Subject: N192216430 - Special Coverage  
Airbag Light On Due to PPS Sensor Disconnect

Models: 2014-2017 Chevrolet Impala  
Equipped with Front Heated Seats (RPO KA1)

# Special Coverage Adjustment

## N192216430 Airbag Light On Due to PPS Sensor Disconnect

4920551

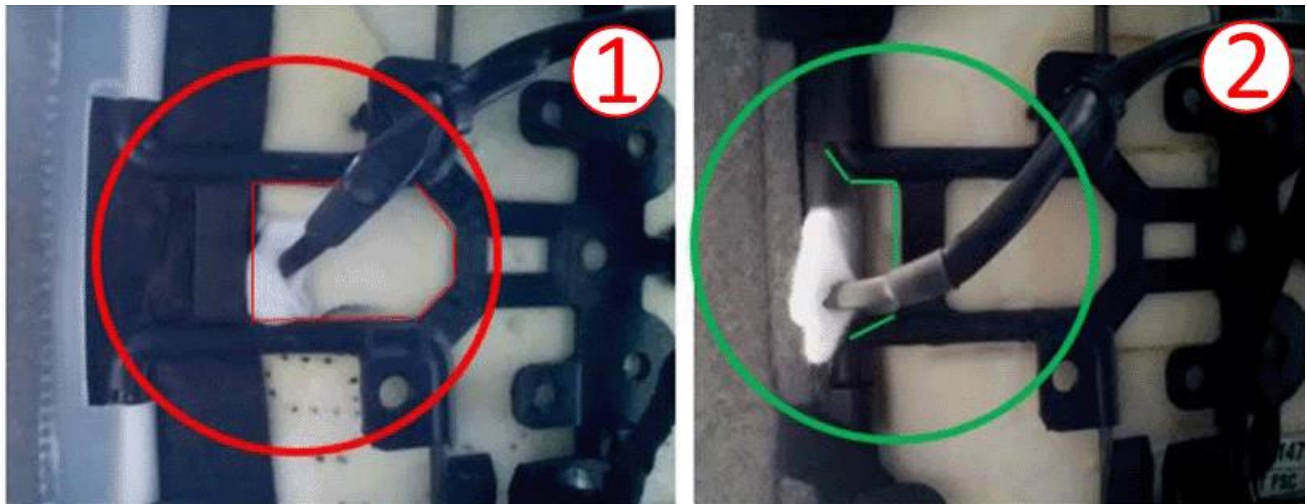
**Note:** The graphic above depicts the incorrect pigtail harness route (1) and the correct pigtail harness route after repair (2).

4. Using care, insert the PPS sensor mat pigtail (3) back through the foam opening making sure not to bend the sensor. Do not open the felt (1) covering the connectors.
5. Install the cushion onto the seat frame. Refer to *Front Seat Cushion Cover and Pad Replacement* in SI.
  - The sensor tail must be routed through the rear suspension opening below the seat frame (2) hanging freely.
  - Validate the wiring harness (3) has proper movement.

6. Reconnect all electrical connectors and install the trim cover. Refer to *Front Seat Cushion Cover and Pad Replacement* in SI.
7. Install the passenger side seat. Refer to *Driver or Passenger Seat Removal and Installation* in SI.
8. Check the PPS Module for any DTCs in history status and clear DTC.
9. Perform the Passenger Presence System Preload Test (PPS Setup). Refer to *Passenger Presence System Preload Test (PPS Setup)* in SI.

5507383

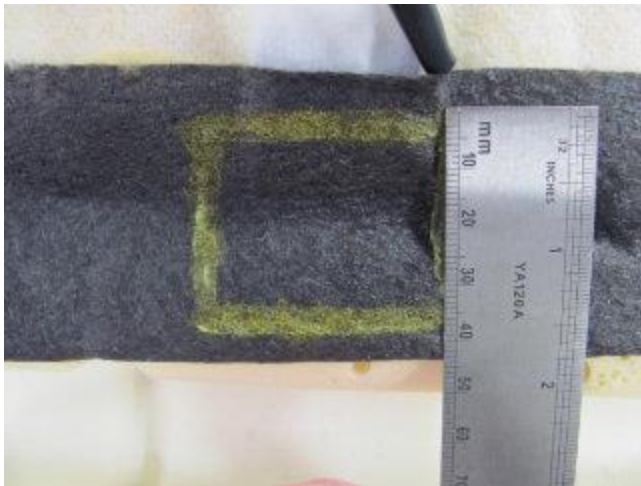
**IMPORTANT:** If the vehicle VIN begins with a 1, the vehicle was built in the US. These vehicles require a modification to the seat cover retention band. See the Modification for US Built Vehicles after step #9.

1. Before separating the seat cover from the foam pad, locate the fabric seat cover retention band.

2. Using a paint pen, mark a 40mm (1.5in.) by 40mm(1.5in.) area on the retention band at the area where the wiring harness passes through the foam cushion.

3. Cut along the marked lines, create a "window" in the seat cover retention band.
4. When installing the seat cover onto the new cushion, ensure the harness passes through the "window".
